EGG-NE-10184  
EGG-xxxx

TECHNICAL EVALUATION REPORT

TUE-1 DEPARTURE FROM NUCLEATE BOILING CORRELATION

Prepared for the  
U. S. Nuclear Regulatory Commission  
Washington, D.C. 20555  
Under DOE Contract No. DE-AC07-76ID01570  
FIN. No. L1696  
Task Order No. 4

FIGURE 1.

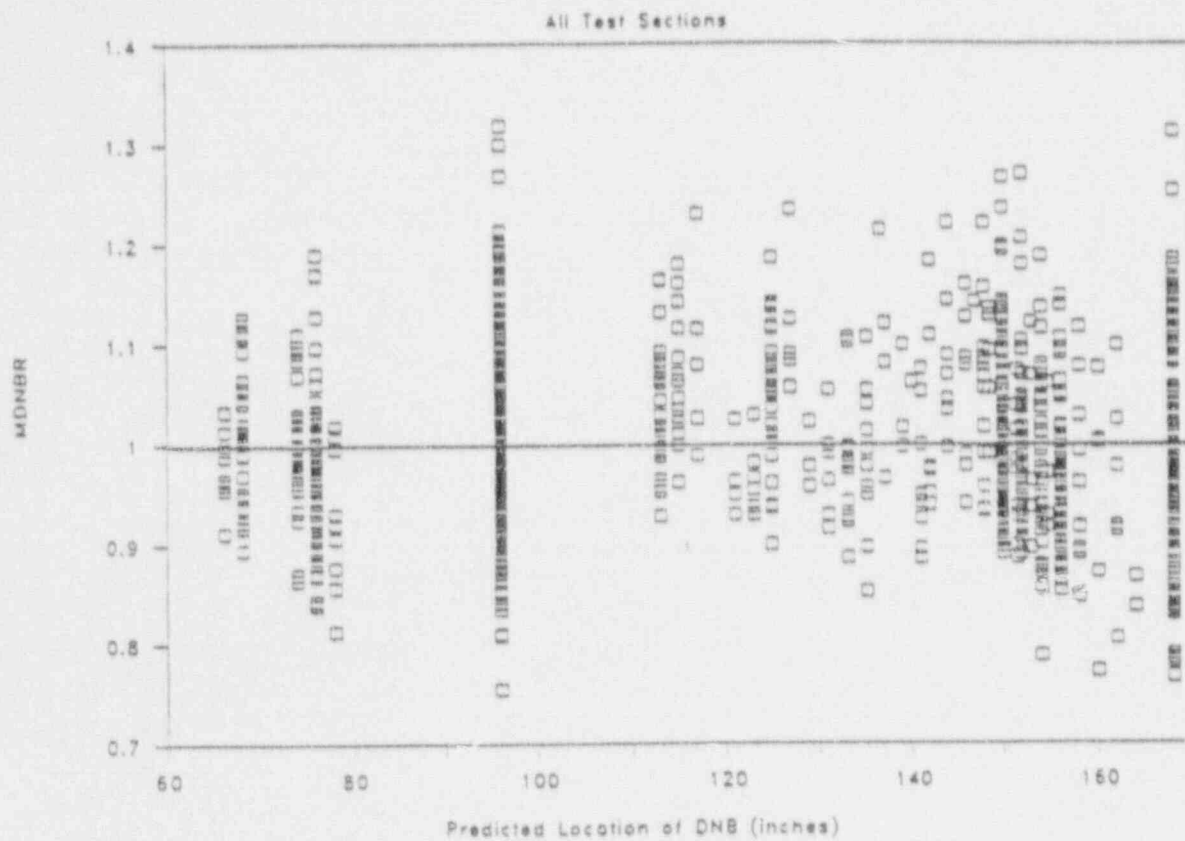
3. NRC Request: To make the table on page 2-5 [of RXE-88-102] complete, please identify the ranges for the following parameters: 1) fuel rod diameter, 2) thimble guide tube diameter, 3) rod pitch, 4) distance from inlet at which DNB occurred, and 5) enthalpy at the DNB location. Please also supply the inlet temperature for the tests.

The range of the distance to DNB over which the correlation is considered applicable is not limited to distances greater than 68 inches even though this represents the lower limit of the experimental data used in the correlation development. As Figure 1 (attached) shows, the behavior of the calculated MDNER exhibits no trend with changing distances to DNB. This behavior indicates that extrapolation below the 68" value is acceptable.

FIGURE 2.

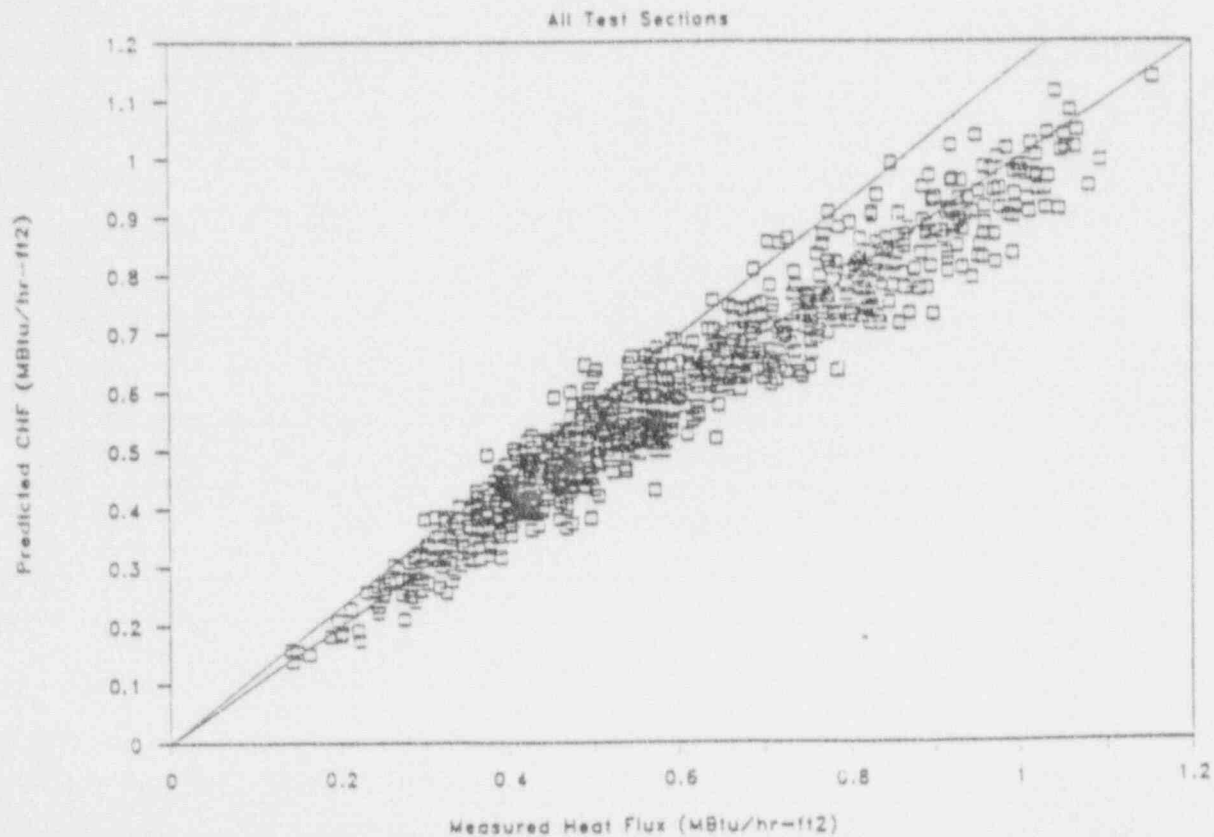
4. NRC Request: To allow for a more quantitative measure of the bias, please provide fits of QDNB predicted as a function of QDNB measured for each test section and for all data combined. The intercept of the fits should have the value 0.0, with a slope of 1.0.

TU Electric Response: The fits of QDNB predicted as a function of QDNB measured for all data combined and for each test section individually have been performed using linear regression. The results of the linear regression fits are summarized in Table 1. Plots of predicted CHF versus measured heat flux for all test data combined and for each test section are provided in Figures 2 through 21. Two lines are shown on each plot. The top line represents the locus of points corresponding to a MDNER of 1.16, which is the 95/95 limit for the TUE-1 DNB correlation. The other line represents the locus of points corresponding to a MDNER of 1.0.
